R-27 Well Installation

**From:** Cobrain, Dave, NMENV  
**Sent:** Thursday, October 27, 2005 2:51 PM  
**To:** 'Mark Everett'; Young, John, NMENV  
**Cc:** 'Whitacre, Thomas'  
**Subject:** RE: R-27 Proposed Well Design w/attach.

# R-27 Well Design

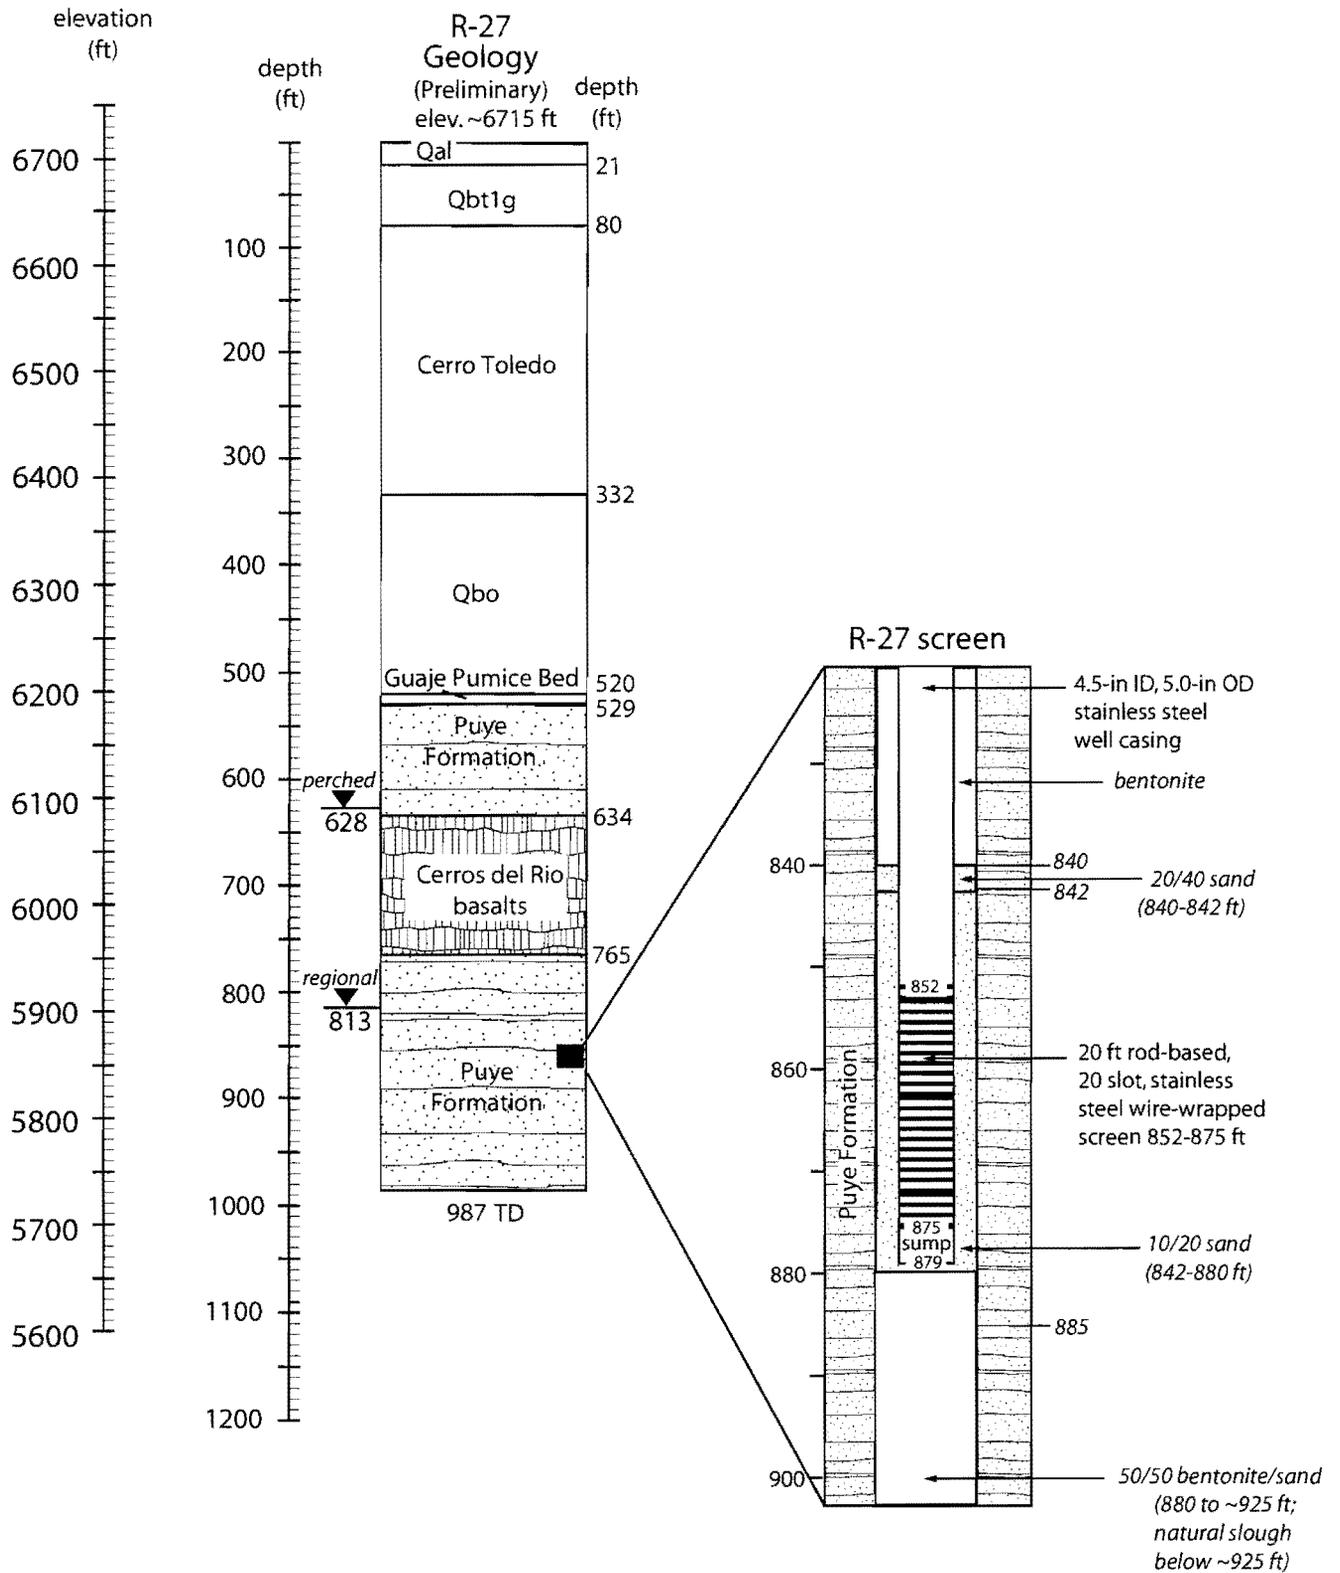
Based on our phone conversation this afternoon (10-27-05) and the attached well design, NMED approves of the well installation. NMED understands that a water sample was collected from the perched zone located at the base of the Puye Fm. overlying Cerros del Rio Basalt at approximately 628 ft below ground surface and that preliminary results indicate that contamination was not present in the perched groundwater. NMED also understands that advancing the boring to 1100 ft below ground surface and also installing a deeper, second screened interval was not practicable due to drilling conditions.
